SERVICE BULLETIN No: 105
 REVISION: A, 3 Aug 05. (Prepared 2 Aug 05)
 SUBJECT: Tail Drive System Inspection
 SHIPS AFFECTED: See below
 TIME OF COMPLIANCE: Within the next 10 hours TIS. See below for details.
 FAA APPROVAL: This Service Bulletin is FAA approved.

Brantly has had reports of failures of the 'shaft upper tail rotor' (p/n 249-10). The purpose of this service bulletin is to inspect the condition of the shaft and parts in that assembly. The inspections are separated into two parts. Part one contains one-time inspections that must be repeated only under certain circumstances. Part two contains inspections that must be repeated periodically and under certain circumstances. See the inspections for specifics.

Fig. SB-105-1

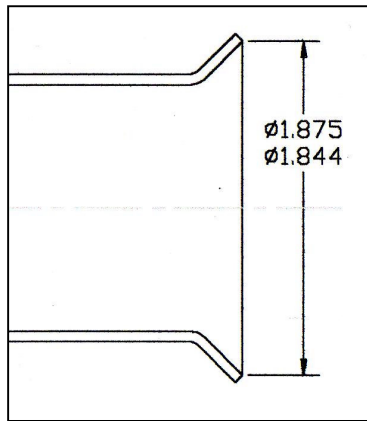
2.6 Tail Rotor Gearbox Assembly (p/n 278-200): Assemble the (upper) tail rotor gearbox assembly (p/n 278-200). Add the housing (p/n 249-3). Check the internal alignment of the shaft (p/n 249-10) as follows: Position the assembly such that the shaft is horizontal. The cone end of the male coupling must rest, under its own weight, within .031 inches or below the center of the housing (p/n 249-3) along a vertical line. Repeat the check in at least 4 equally spaced positions when you roll the entire assembly along the shaft axis. The mid-span bearing (p/n 108-64) is part of only some helicopter configurations. If it is part of the ship being inspected then perform the internal alignment check both with and without the bearing installed. If the assembly fails this check then the problem must be found and corrected or the entire assembly must be replaced with an airworthy assembly. Contact the factory if you need assistance. (Ref. SI-10 “Upper Tail Rotor Gearbox Assembly, Installation, Maintenance”)

Fig. SB-105-2

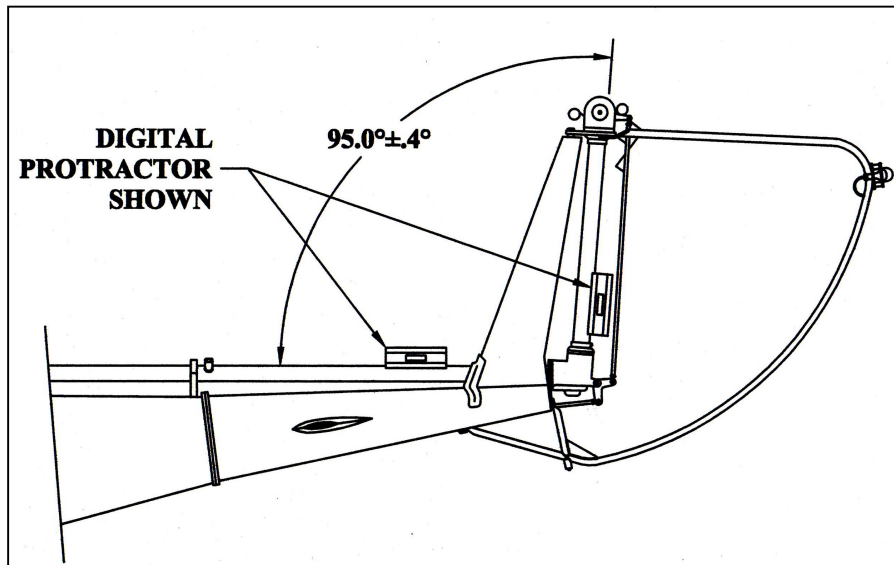
- 4) Once the assembly is fully installed and all fasteners are torqued within the required values, measure the angle between the tail rotor shaft housings (p/n 249-3 and p/n 14-13). Angle must be 95.0° ± 0.4°. (See fig SB-105-2)
